Service Letter: 459

Title: Inspection of Rudder & Vertical Stabilizer Upper & Lower Hinge

Models: All American Champion / Bellanca 7AC, 7BCM, 7CCM, 7DC, 7EC, 7FC, 7GC, 7GCB, 7HC, 7JC, 7KC, 7GCA, 7GCBA, 7ECA, 7GCAA, 7KCAB, 7GCBC, 7ACA, 8KCAB, & 8GCBC.

FIGURE 1 : TAIL SURFACE INSTALLATION

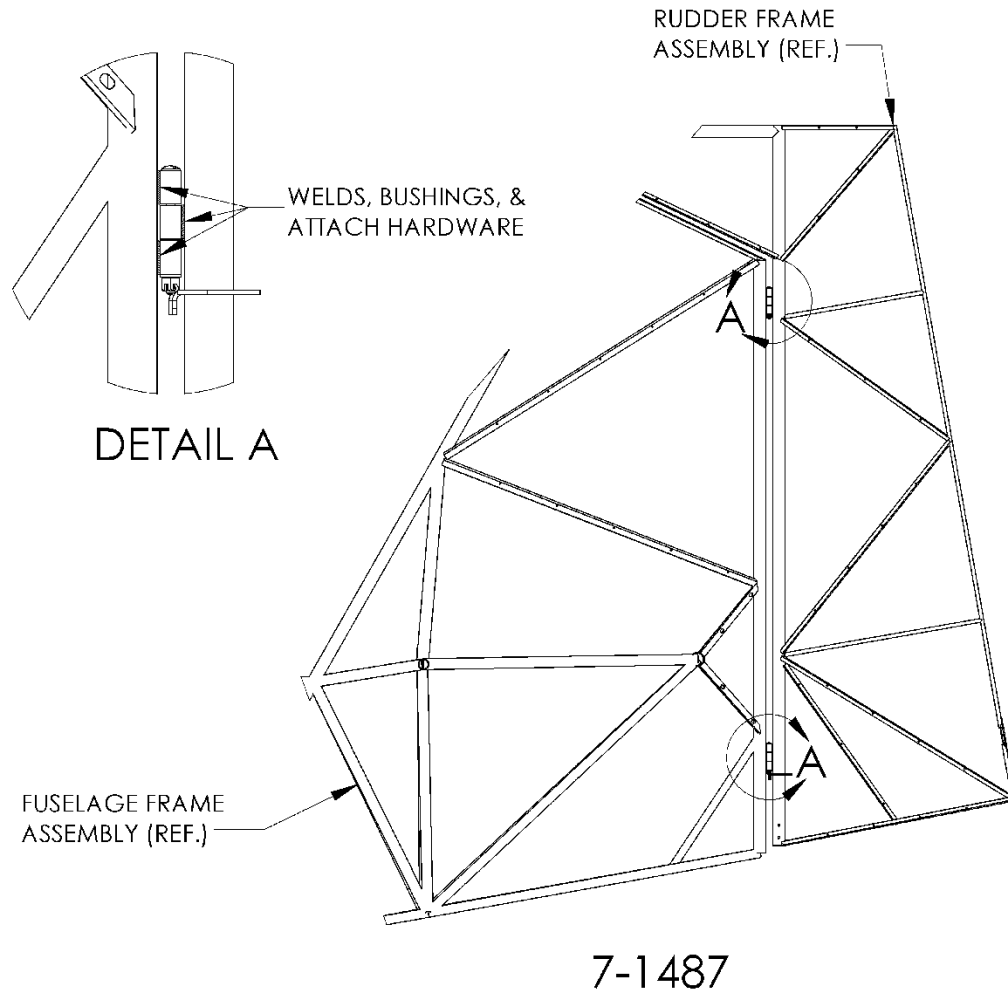
4. Visually inspect the weld surfaces shown on Figure 1 Detail A for cracks, porosity, undercut, and/or lack of fusion. Ensure to inspect the material around the weld as cracks can propagate from the weld. With a 10-times magnification lens, methodically inspect the entirety of each of the weld beads shown on Figure 1 Detail A. Ensure to pay close attention to the toe lines (where the weld meets the metal) as this is the most common initiation point for cracking. Identify if there are any micro-cracks, voids, small holes, pores, or other irregularities in the welds. Consult FAA AC 43.13-1B, paragraph 4-78 to determine if the welds are within acceptable limits.

5. If no irregularities are found and the welds are within acceptable limits per FAA AC 43.13-1B, paragraph 4-78, record satisfactory inspection to SL 459 (initial revision, dated 4-16-2025 or later) in the aircraft logbook.

6. If the welds or other irregularities are found to not be within acceptable limits, the relevant components need to be replaced.
